ANSTY GARDEN COMMUNITY,

DESIGNERS RESPONSE

REPORT REF NO. 2207280-R14

- 1.6 The following drawing have been prepared to incorporate the findings of the RSA:
- **ACE Drawing 2207280-004D** – Proposed Roundabout Western Access (A272)

Drawing Number: **2207280-004**

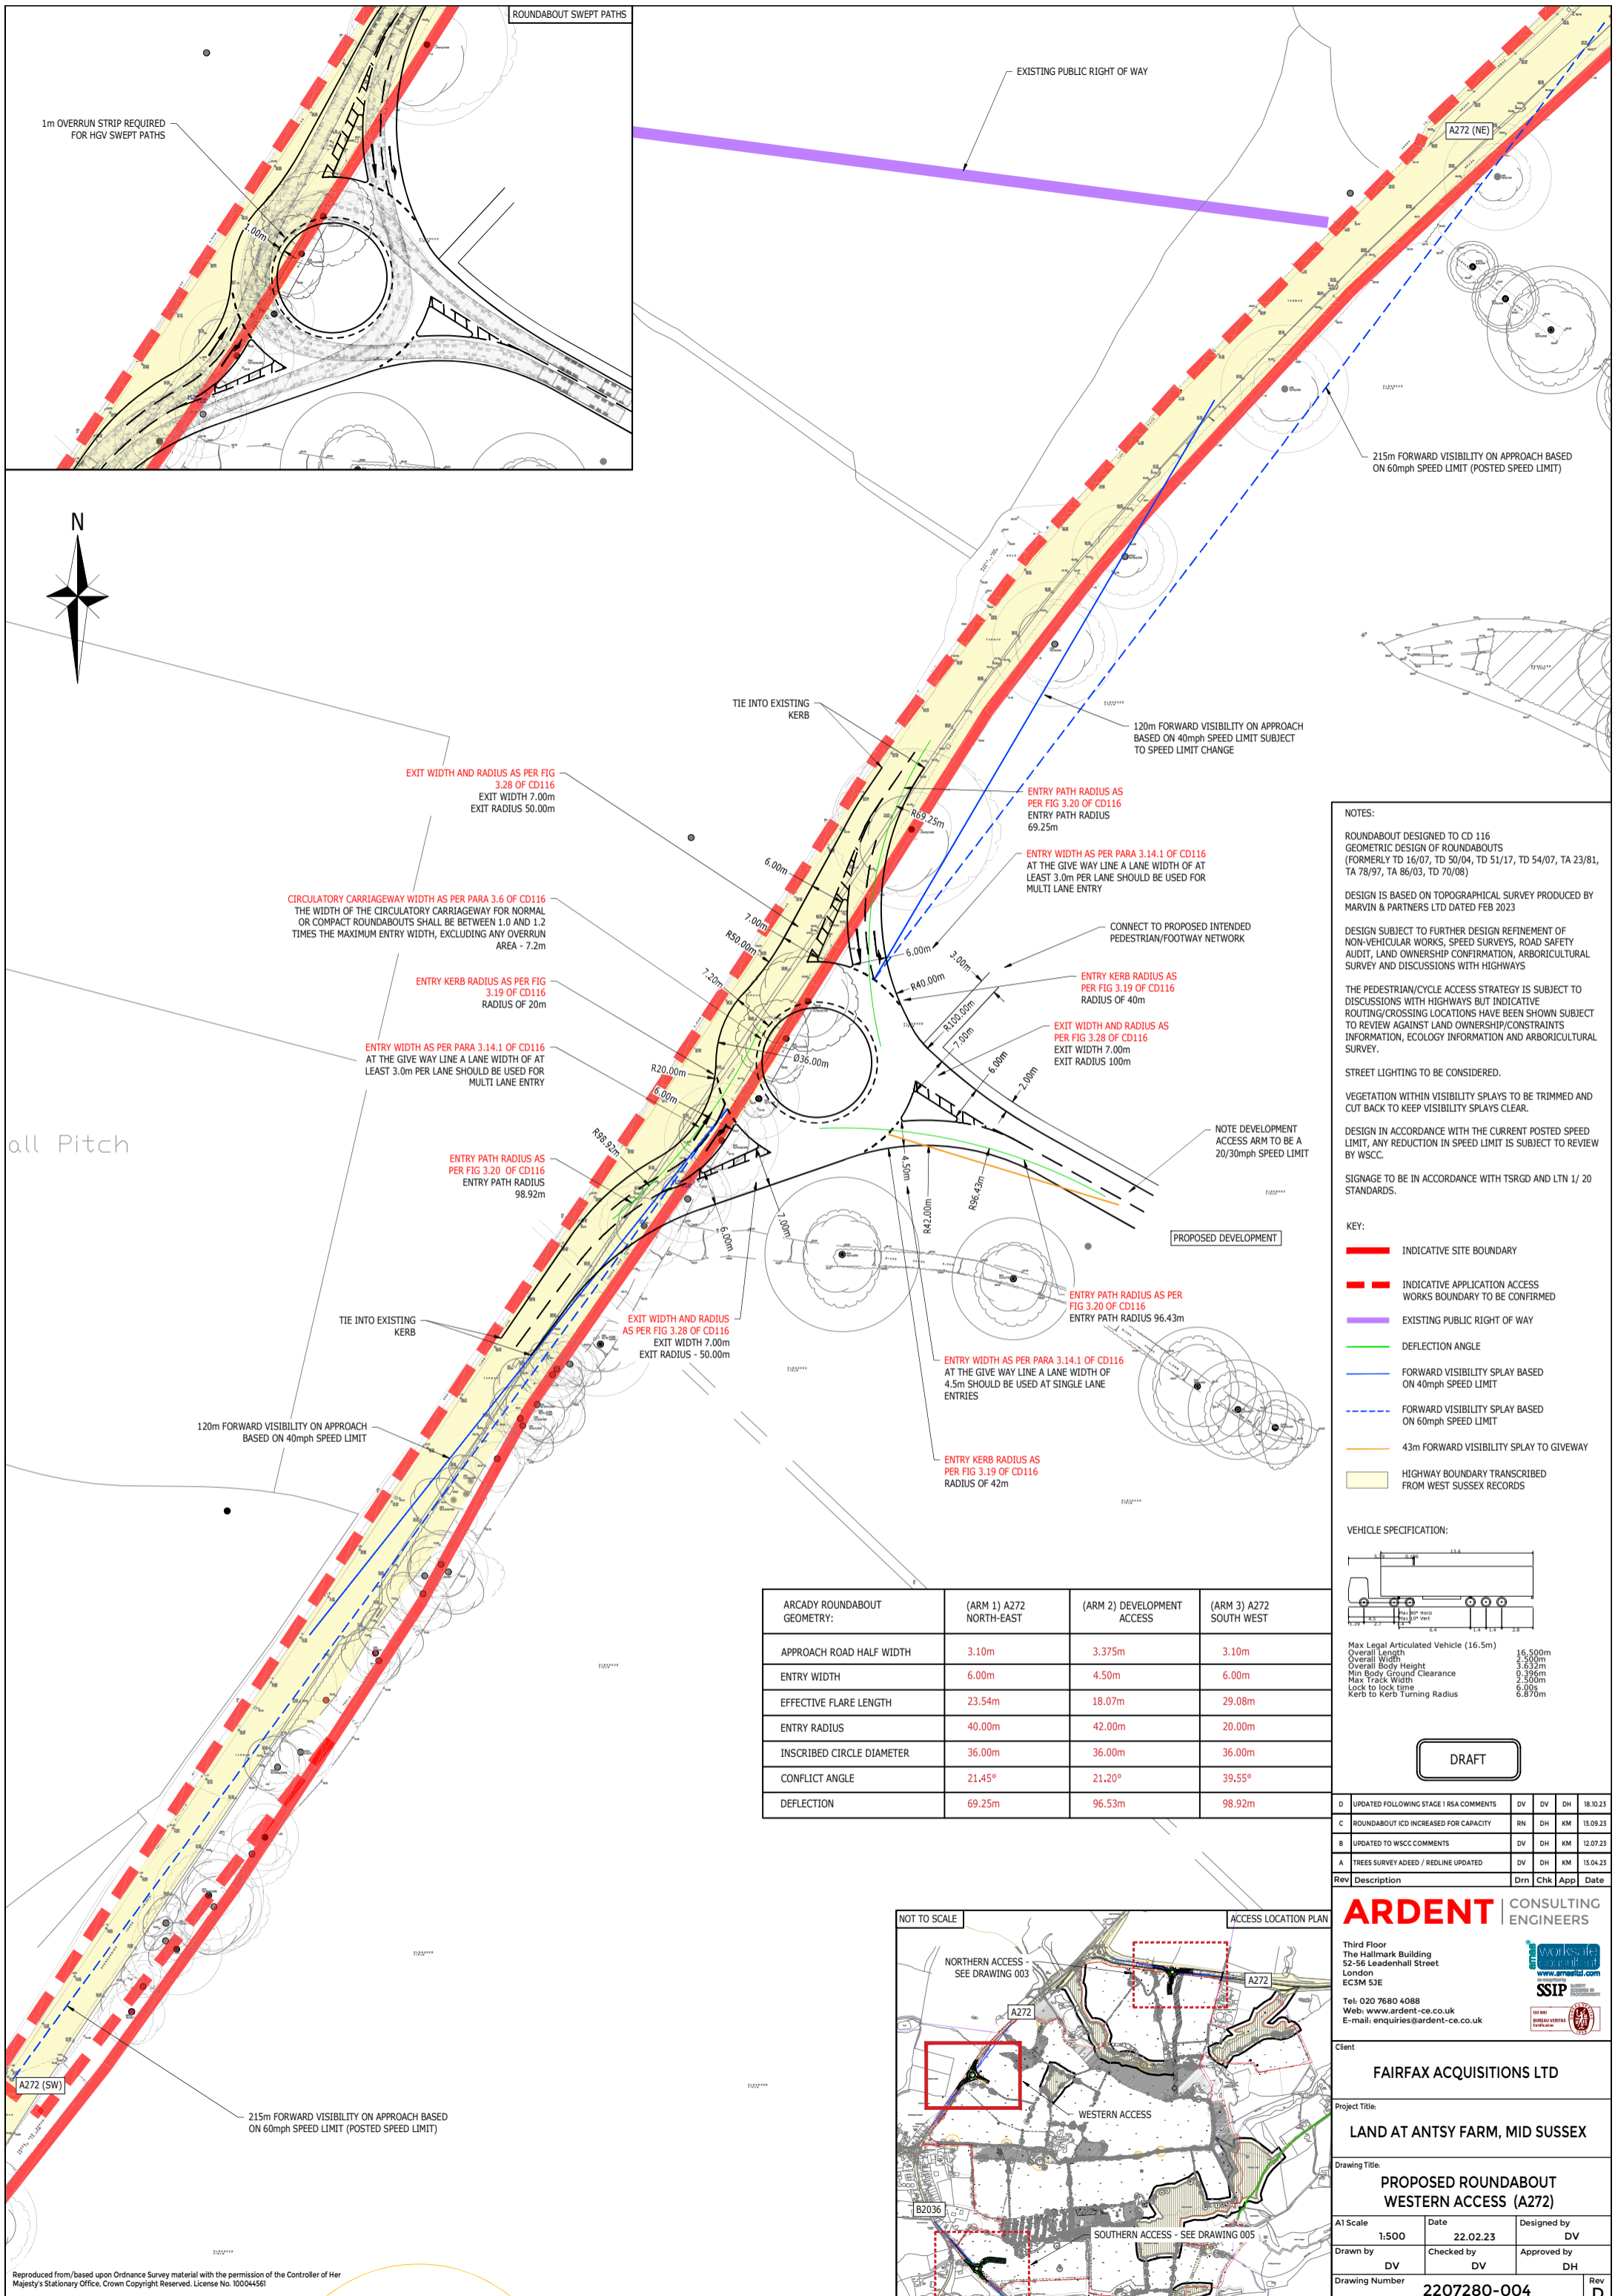
<p>3.2.2 Insufficient Stopping Sight Distance may increase the risk of junction related or shunt type collisions at the roundabout.</p> <p>On the southwest bound approach to the roundabout SSDs have been provided for assessment. However, there is concern that the SSDs pass over non-highway land. Vegetation or landscaping features in these splays could restrict visibility, where insufficient visibility may increase the risk of junction related or shunt type collisions at the roundabout.</p>	<p>It is recommended that a suitable covenant should be arranged to ensure that the splay is not affected by planting or landscaping features.</p>	<p>All visibility splays are within highway land or land within the development site and therefore can be kept clear as shown and noted on ACE Drawing 2207280-004D.</p>		
<p>3.2.3 Insufficient Stopping Sight Distance may increase the risk of junction related or shunt type collisions at the roundabout.</p> <p>On the approach to the roundabout no SSD has been provided for assessment. There is concern that the SSD could pass over non-highway land. Vegetation or landscaping features in this splay could restrict visibility, where insufficient visibility may increase the risk of junction related or shunt type collisions at the roundabout.</p>	<p>It is recommended that the SSD should be supplied for assessment and that they should be within the adoptable highway, or that a suitable covenant should be arranged to ensure that the splay is not affected by planting or landscaping features.</p>	<p>The development arm of the roundabout will be subject to a 20/30mph speed limit. All visibility splays are within highway land or land within the development site and therefore can be kept clear as shown and noted on ACE Drawing 2207280-004D.</p>

<p>3.2.4 Lack of vertical profile information could lead to side impact collisions or loss of control collisions.</p> <p>The proposed roundabout is located on the A272, where there is a fall from the southwest to the northeast. At this early stage no vertical alignment details were provided for assessment. There is concern that inappropriate vertical profiles could restrict visibility at the junction, which may lead to side impact collisions or loss of control collisions.</p>	<p>It is recommended that vertical alignment details should be provided for assessment at Stage 2 Safety Audit.</p>	<p>Details of vertical alignments will be provided for Stage 2 Audit.</p>		
<p>3.2.5 The exit layouts from the roundabout increase the risk of side swipe collisions, rear end shunts or loss of control collisions.</p> <p>On all arms, the proposed exits from the roundabout are two lanes wide, narrowing to one lane over a short merge length. The layout encourages aggressive drivers to overtake a slower moving vehicle over a relatively short distance. There is concern that such overtaking manoeuvres could lead to side swipe collisions, rear end shunts or loss of</p>	<p>It is recommended that the exits from the roundabout should be restricted to one wide lane.</p>	<p>The exits have been reduced and two marked lanes are no longer proposed. The comment is accepted and drawing updated as set out on ACE Drawing 2207280-004D.</p> <p>The exit widths are in accordance with CD116 Para 3.28.2 <i>'At a normal roundabout, if the downstream link is a single carriageway road, the exit width should be between 7 metres and 7.5 metres and the exit should taper down to a minimum of 6 metres. NOTE The</i></p>

<p>control collisions, particularly as one of the of the merges is on a bend.</p>		<p><i>additional width allows traffic to pass a broken down vehicle.'</i></p> <p>The amended design accords with DMRB requirements as shown on ACE Drawing 2207280-004D.</p>		
<p>3.3.1 Insufficient capacity could lead to rear end shunt or side impact collisions.</p> <p>No details of expected flows and the capacity of the roundabout have been provided for assessment. Insufficient capacity could lead to congestion where excessive queuing at the roundabout could lead to driver frustration and the use of inappropriate gaps, further unbalanced flows could lead to entry problems on to the roundabout. This may lead to rear end shunt or side impact collisions.</p>	<p>It is recommended that the roundabout should operate without excessive queuing and with balanced flows and that an ARCADY or similar model should be provided for assessment.</p>	<p>An ARCADY assessment has been undertaken and demonstrates that the junction operates with spare capacity in the Development Case scenario. The results are attached at Appendix C.</p>

<p>3.3.2 Low angle of entry may increase the risk of side impact collisions.</p> <p>The angle of entry was provided for assessment, where for northeastern and development arms the angle of entry was less than twenty degrees. Low angles of entry could force drivers to look over their shoulders or use their mirrors to merge with circulating traffic, increasing the risk of side impact collisions.</p>	<p>It is recommended that the angle of entry should lie between 20o and 60o.</p>	<p>Conflict angles have been re-calculated in accordance with CD116 Para 3.18.1. The geometry table has been updated as shown on ACE Drawing 2207280-004D.</p>		
<p>3.5.1 Insufficient street lighting could lead to loss of control collisions and side impact collisions during the hours of darkness.</p> <p>At this early stage no details of street lighting have been provided for assessment. A lack of lighting could increase the risk of loss of control and side impact collisions at the roundabout during the hours of darkness.</p>	<p>It is recommended that street lighting should be checked with the Highway Authority’s street lighting team and that a plan showing the light distribution should be provided for assessment at Stage 2 Safety Audit.</p>	<p>It has been noted on ACE Drawing 2207280-004D that street lighting is to be considered in liaison with WSCC as per the recommendation. Lighting details to be provided for Stage 2 Audit.</p>

Rev	Description	Drm	Chk	App	Date
D	UPDATED FOLLOWING STAGE 1 RSA COMMENTS	DV	DV	DH	18.10.23
C	ROUNDABOUT ICD INCREASED FOR CAPACITY	RN	DH	KM	13.09.23
B	UPDATED TO WSCC COMMENTS	DV	DH	KM	12.07.23
A	TREES SURVEY ADEED / REDLINE UPDATED	DV	DH	KM	13.04.23

At Scale: 1:500	Date: 22.02.23	Designed by: DV
Drawn by: DV	Checked by: DV	Approved by: DH
Drawing Number: 2207280-004		Rev: C

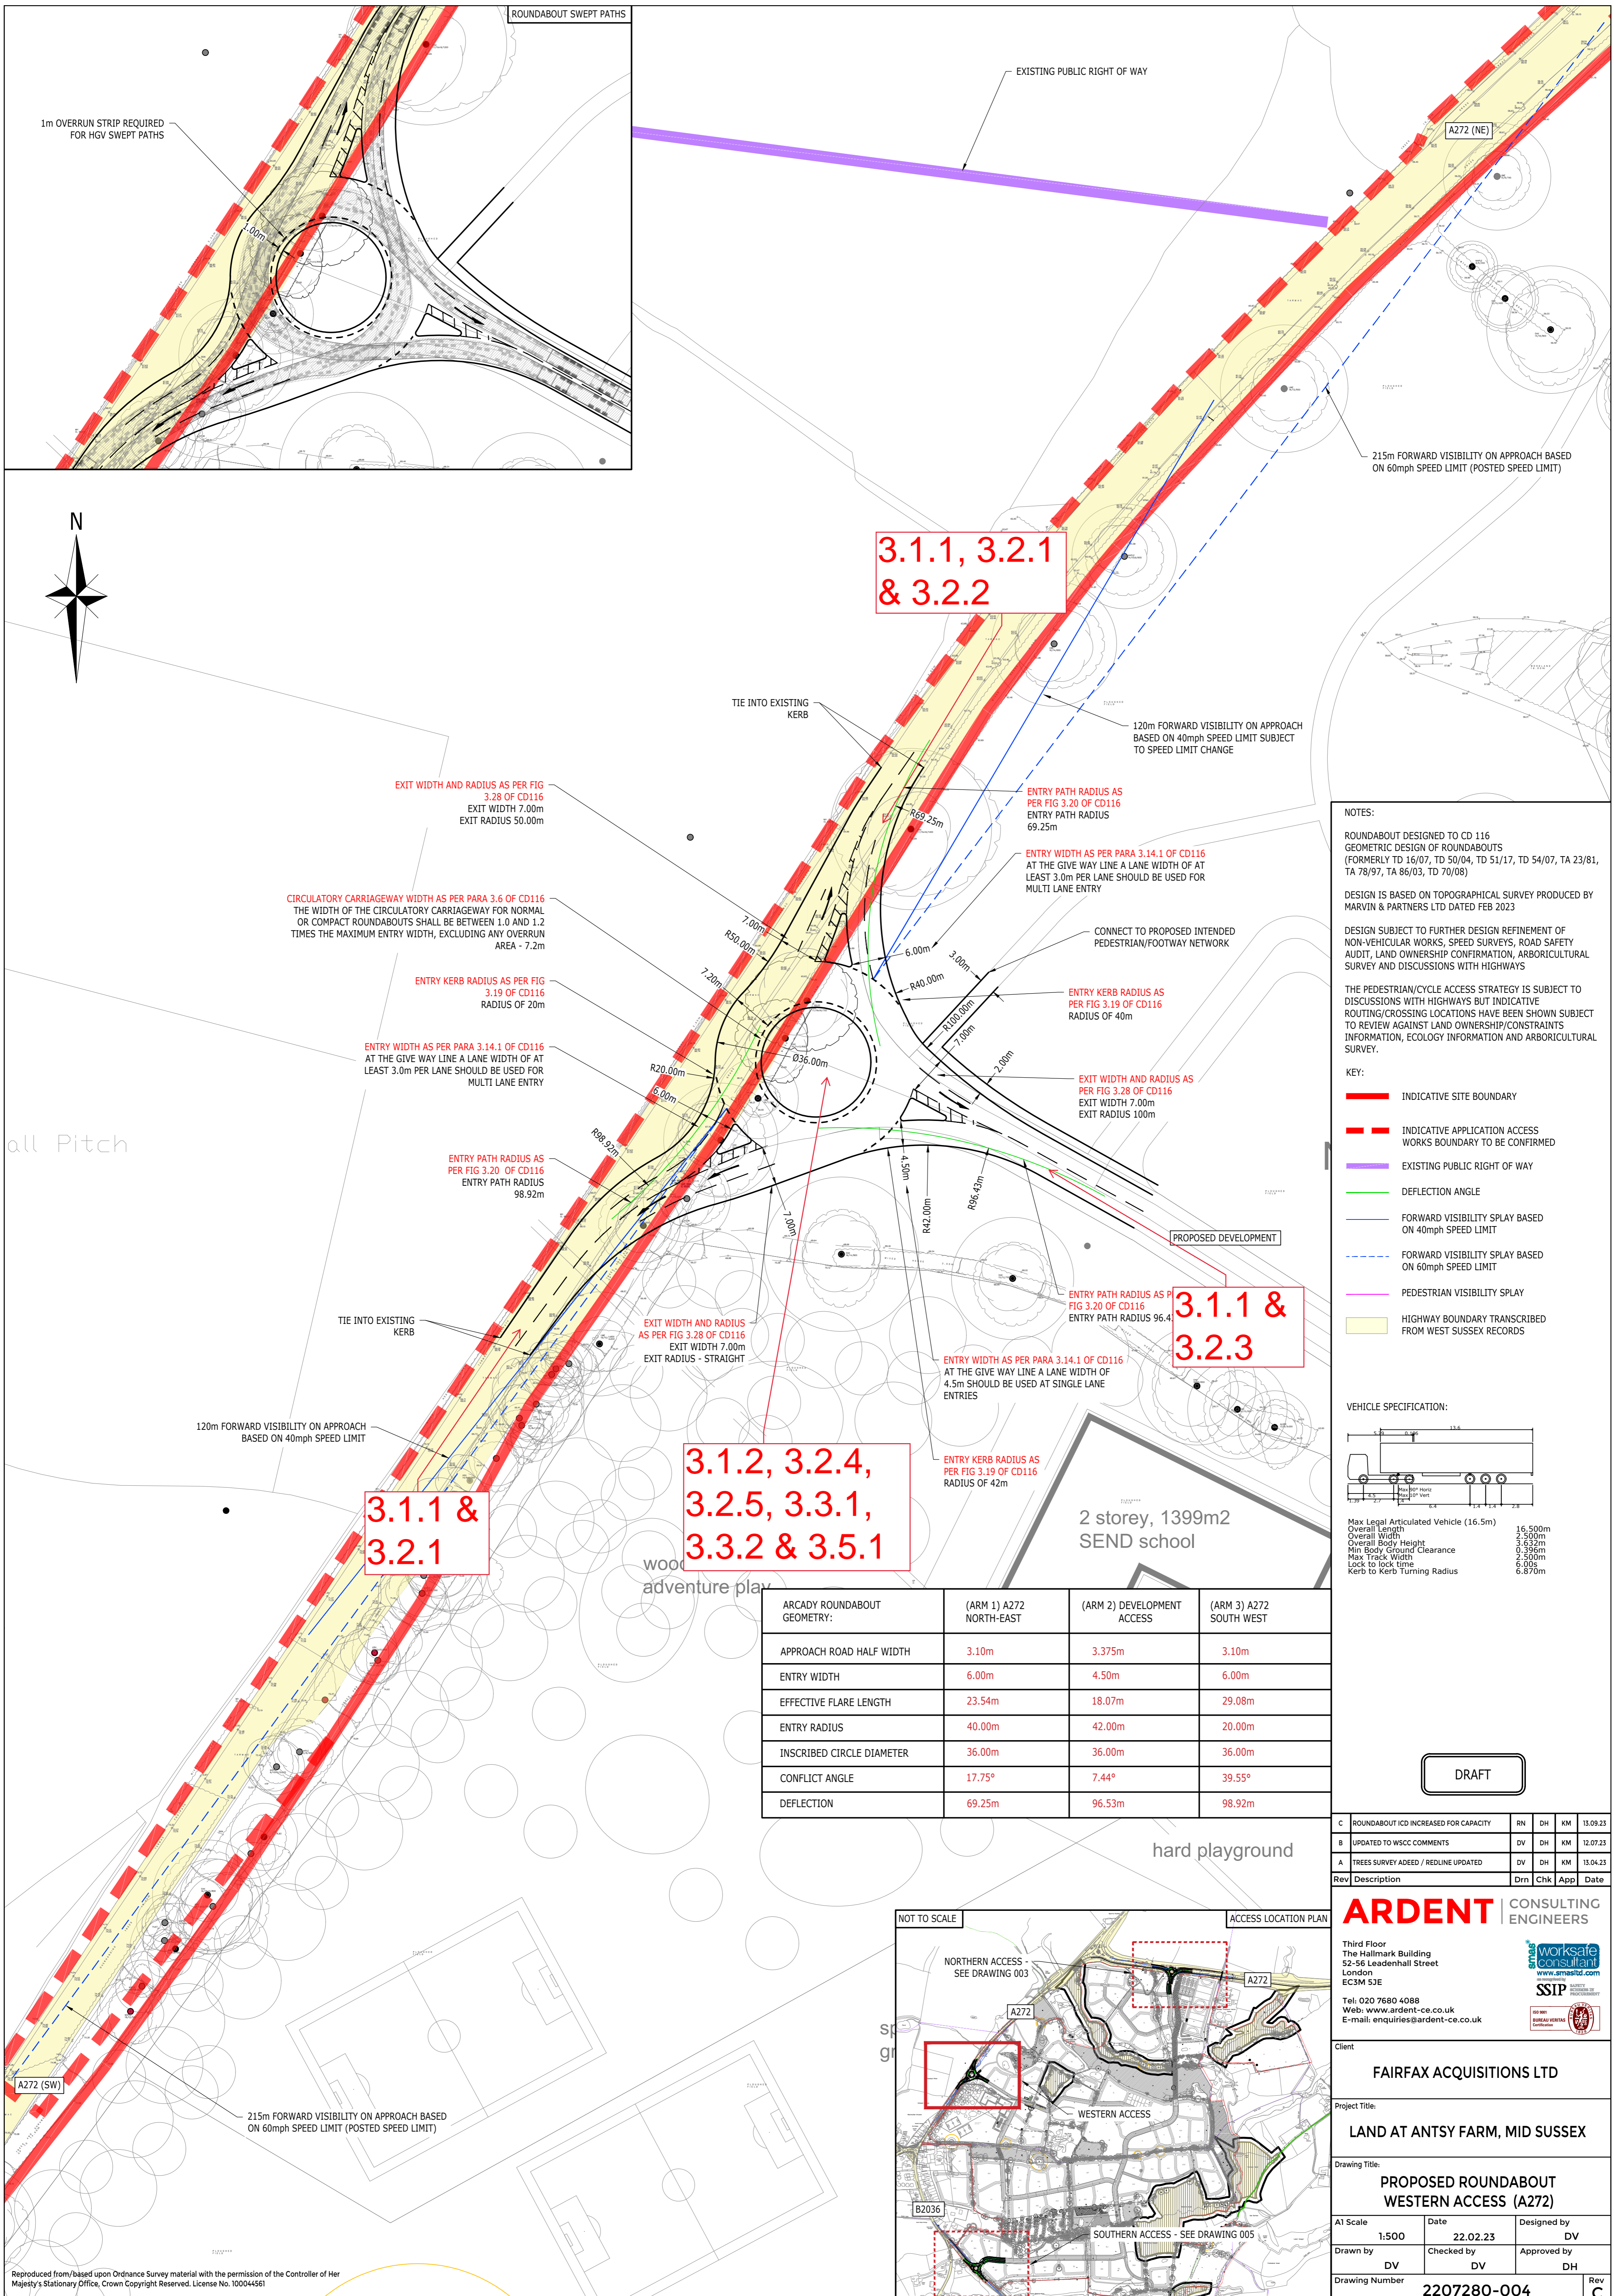
Plan attached showing the locations of the problems identified as part of this audit (location numbers refer to paragraph numbers in the report).
